Bohannon & Huston		Courtyard One 7500 JEFFERSON NE Albuquerque NEW MEXICO 87109		ENGINEERS PLANNERS PHOTOGRAMMETRISTS SURVEYORS SOFTWARE DEVELOPERS		NO. DATE		CC		DESIGN BY:	
		CITY OF ALBUQUERQUE CAPITAL IMPLEMENTATION PROGRAM						CC		DESIGN BY:	
TITLE:		SINGING ARROW NEIGHBORHOOD PARK GRADING PLAN						CC		DESIGN BY:	
DESIGN REVIEW COMMITTEE		CITY ENGINEER APPROVAL		MO./DAY/YR.		MO./DAY/YR.		CC		DESIGN BY:	
				01 07/10/98		05		CC		DESIGN BY:	
CITY PROJECT NO.		ZONE MAP NO.		02		06		CC		DESIGN BY:	
5441.93		L-22-Z		03		07		CC		DESIGN BY:

Singing Arrow
Field Design Revision # ~~21~~ 1
City Project # 5441.93
Date: 07/18/00
Sht 3/3

Singing Arrow
Field Design Revision #2
City Project # 5441.93
Date 07/20/00
Sht 3/3

TITLE: SINGING ARROW
NEIGHBORHOOD PARK
SINGING ARROW AVE. PUBLIC PAVING AND WATER PLAN

Sheet 1/3
N
Scale: 1" = 20'

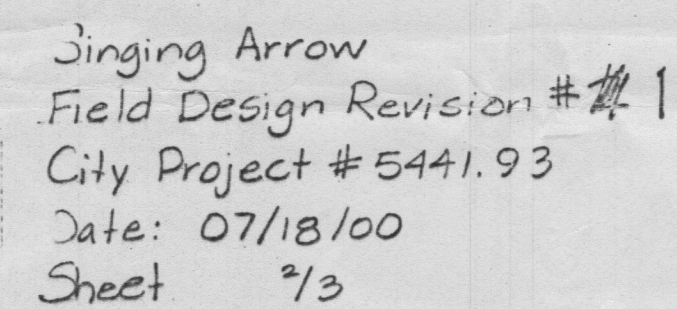
Existing 6" PVC to remain
Type "D" inlet
culverts
New 6" PVC pipes
Area of field design
revision

1. Cut existing 6" PVC pipe at property line.
2. Remove & dispose of existing 6" PVC south of property line (AL)
3. Connect new 6" PVC to existing 6" PVC at property line and extend it 3' south of property line. Invert @ south end of pipe = 2.2
4. Build inlet at south end of pipe. Type "D".
Top of grate (TG) = 3.9, Invert (INV) = 2.2
5. Place expansion joint material around inlet.
6. Contractor shall field adjust inlet to match existing invert of drainage channel
7. New pipe shall maintain same slope as existing pipe.

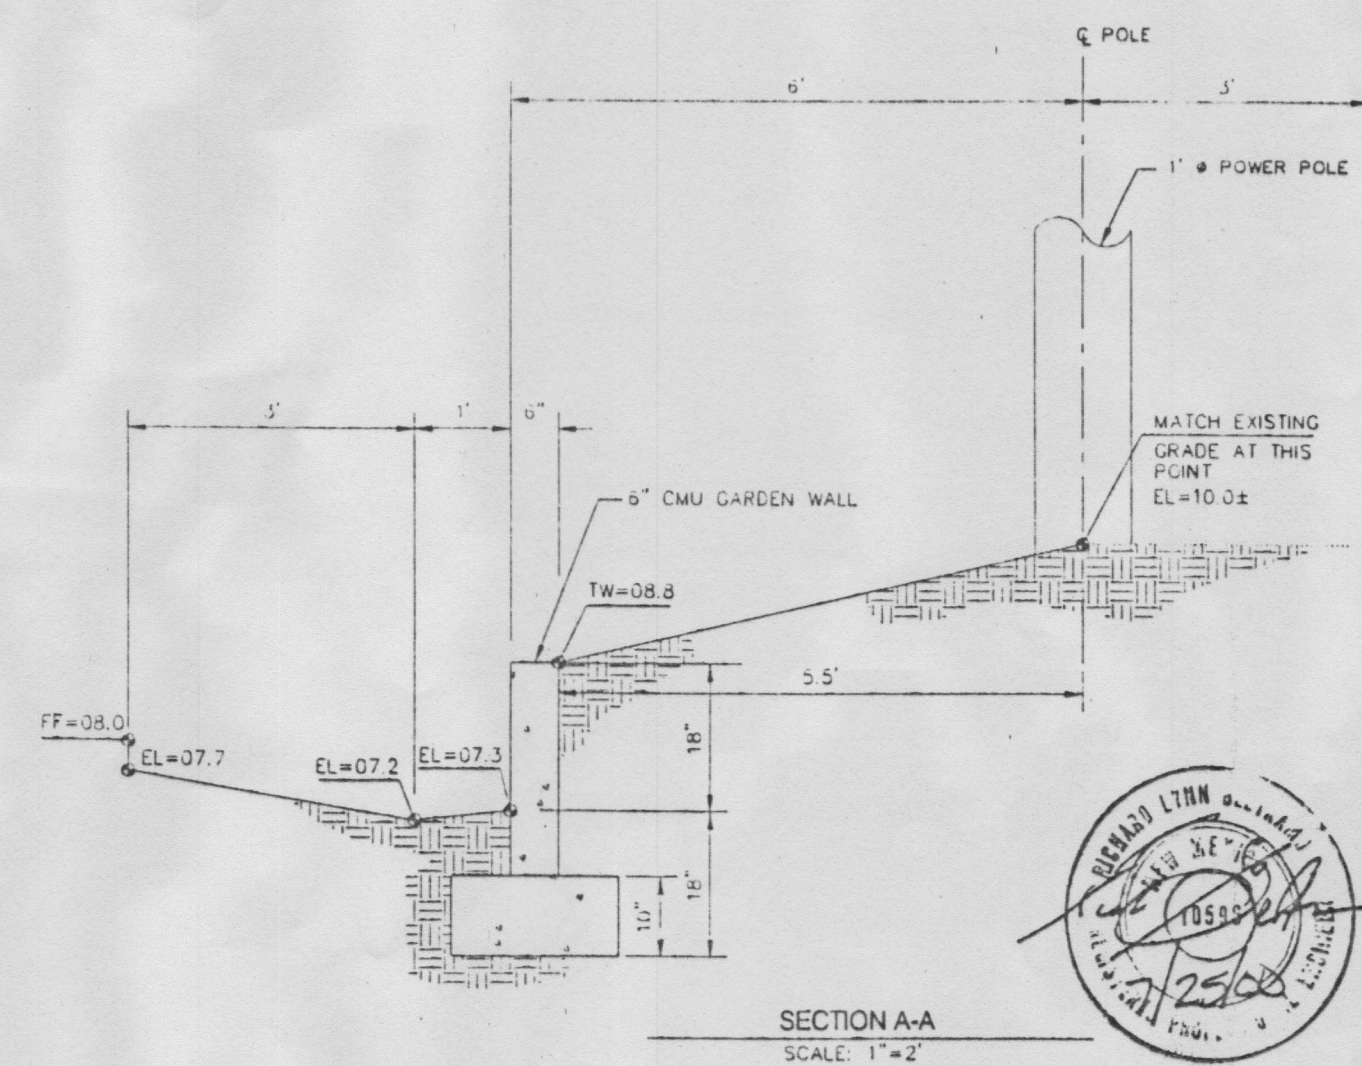
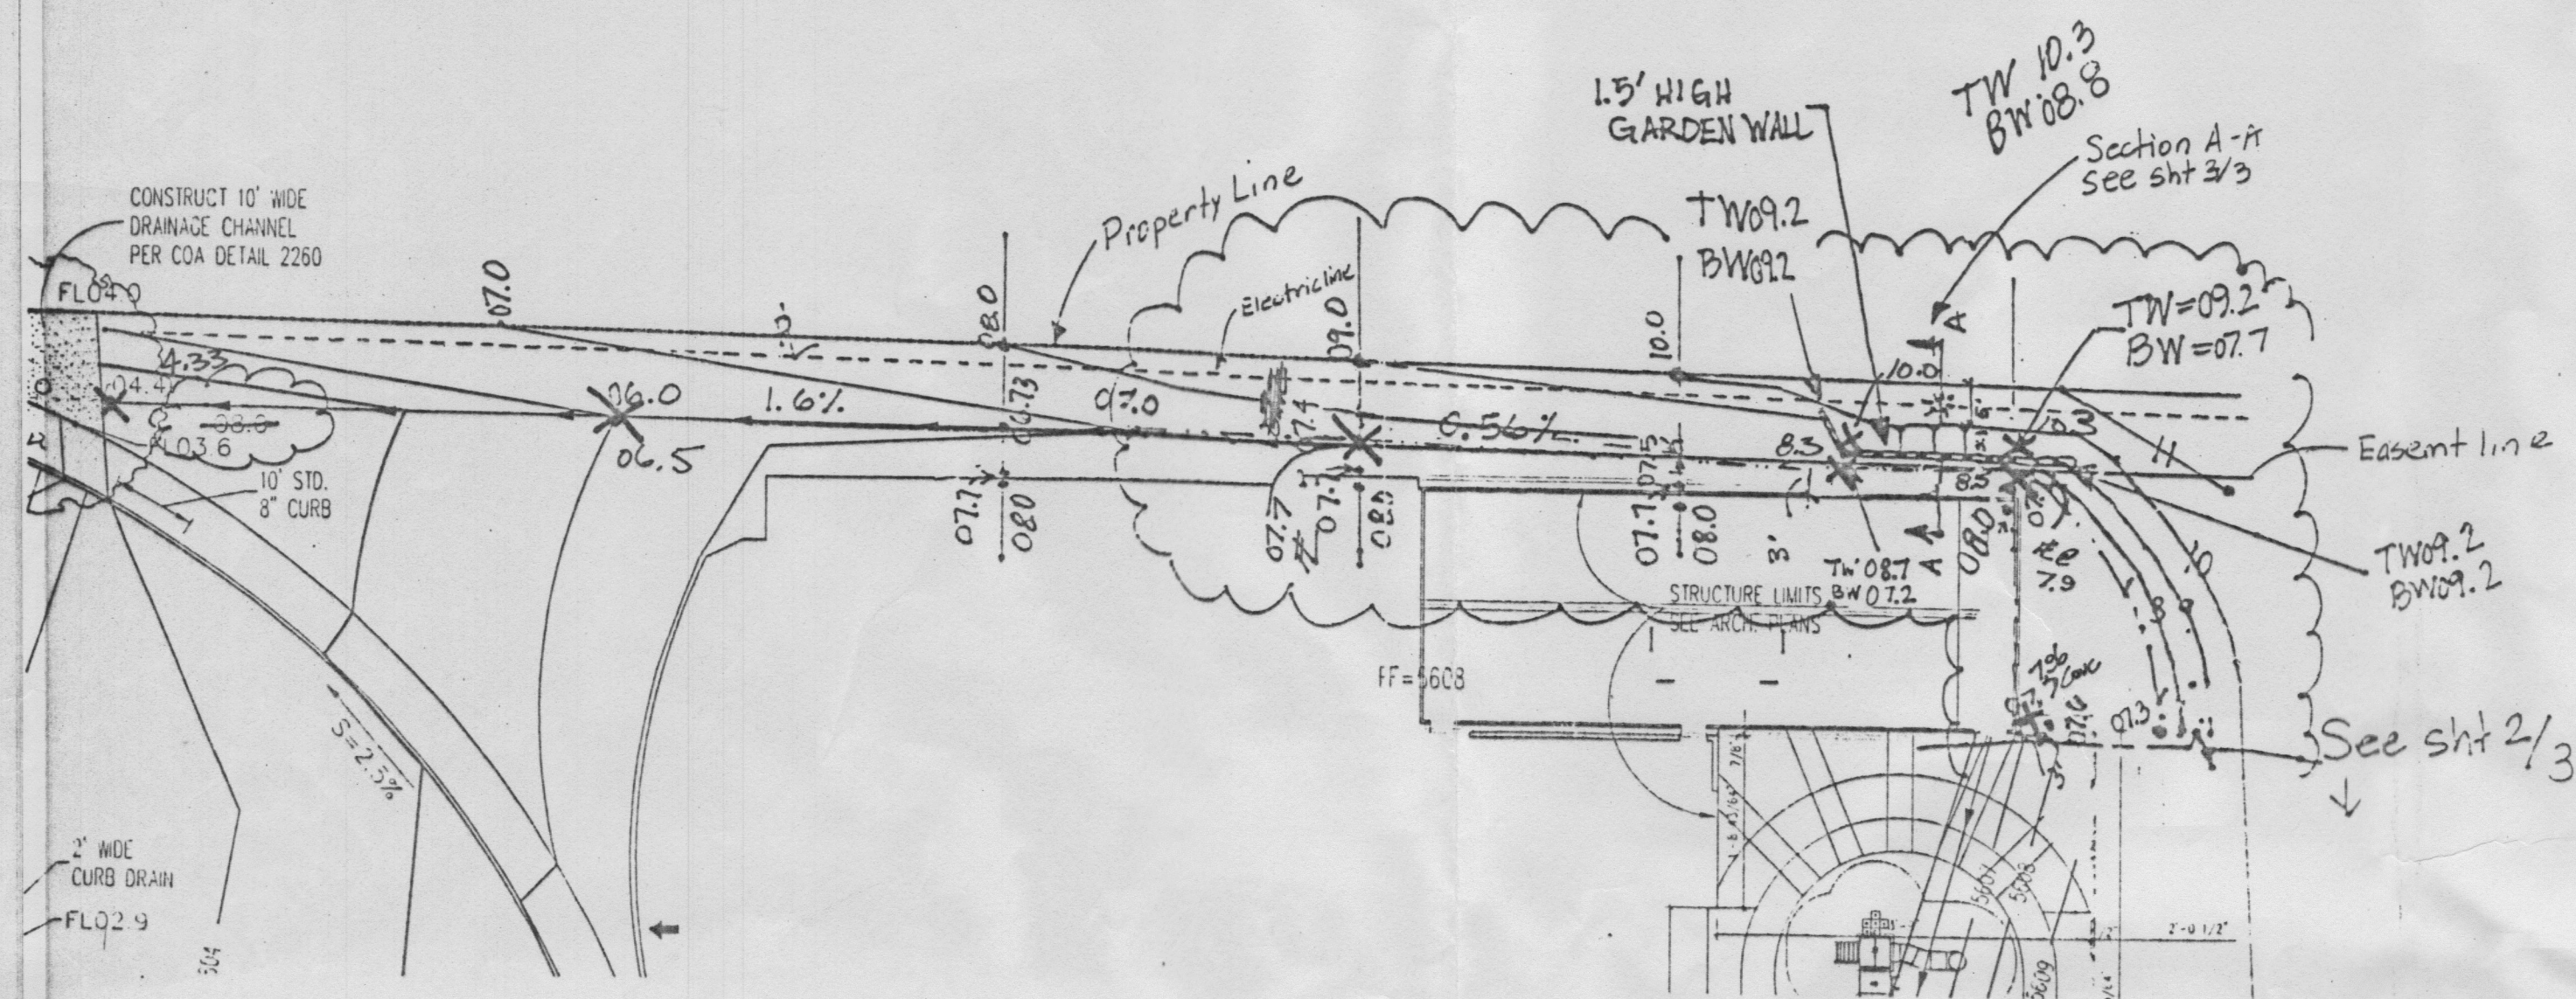
Notes. This Field design revision is intended to define the new swale location, a garden retaining wall around existing light pole, ~~adjusted~~ grades

- Contractor shall insure that proposed ground slopes away from the building.
- Contractor shall not exceed a 3:1 slope at any location on site

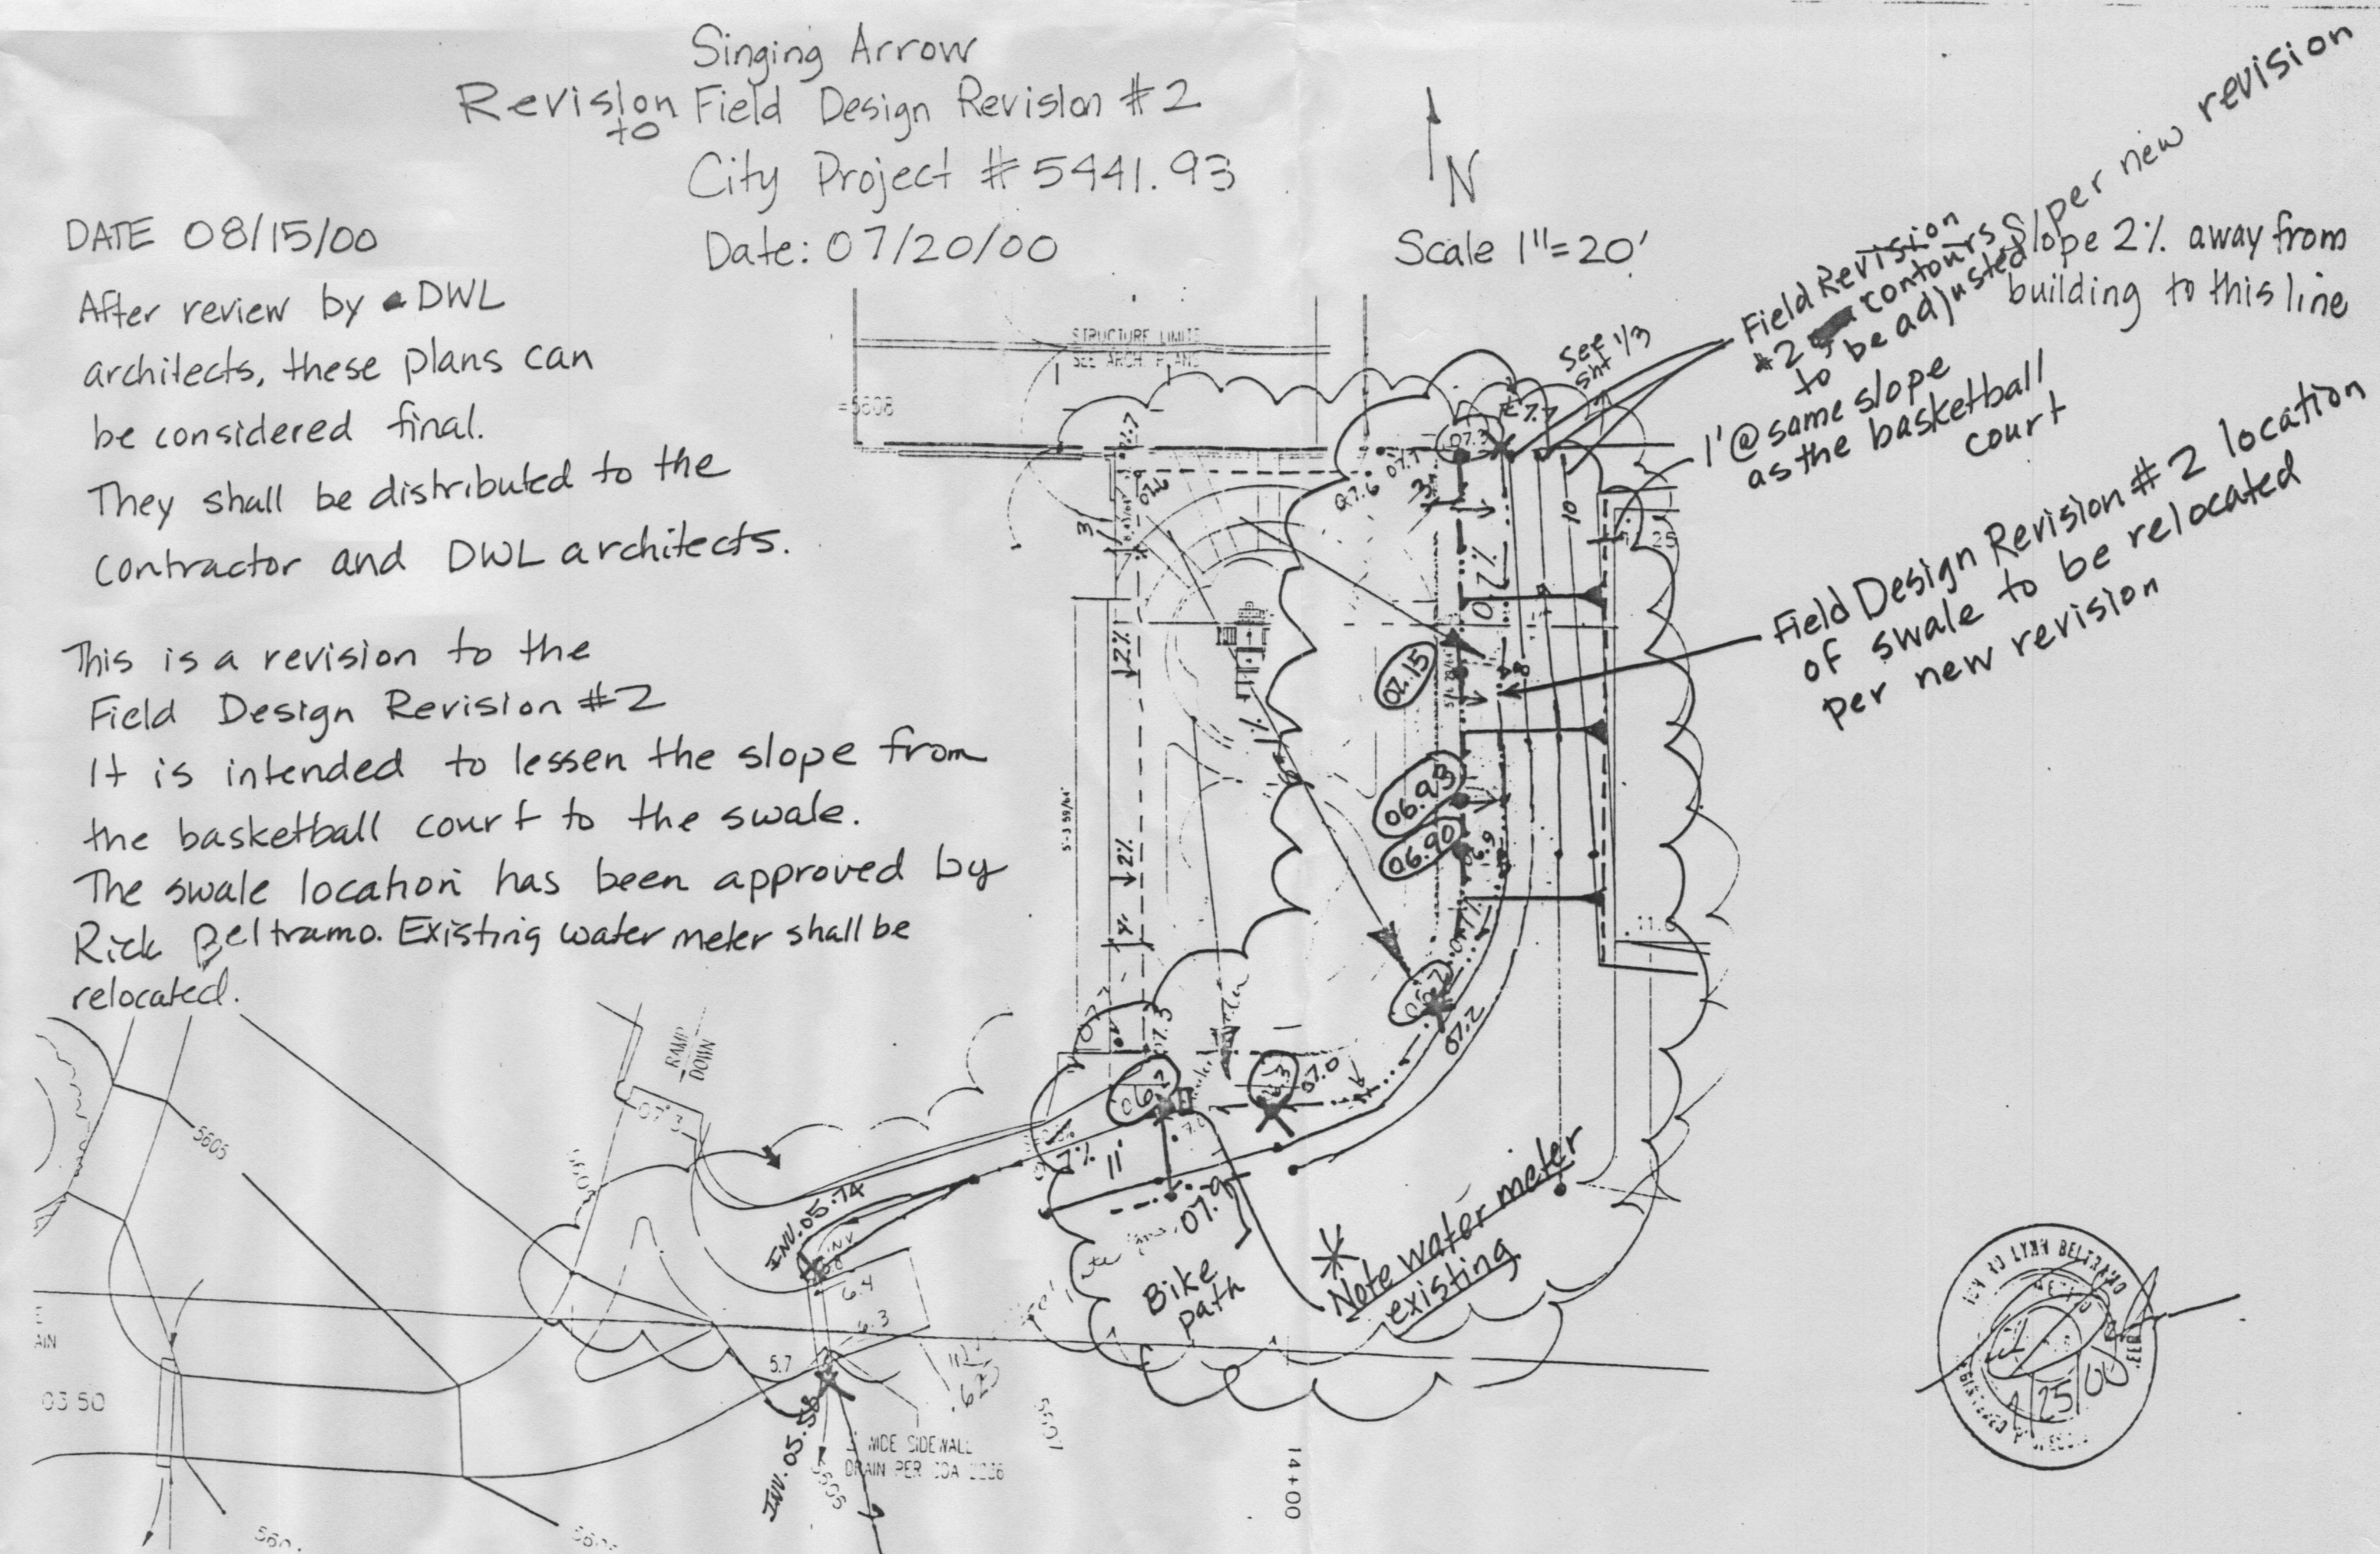
This is a revision to the
Field Design Revision #2
It is intended to lessen the slope from
the basketball court to the swale.
The swale location has been approved by
Rick Peltramo. Existing water meter shall be
relocated.
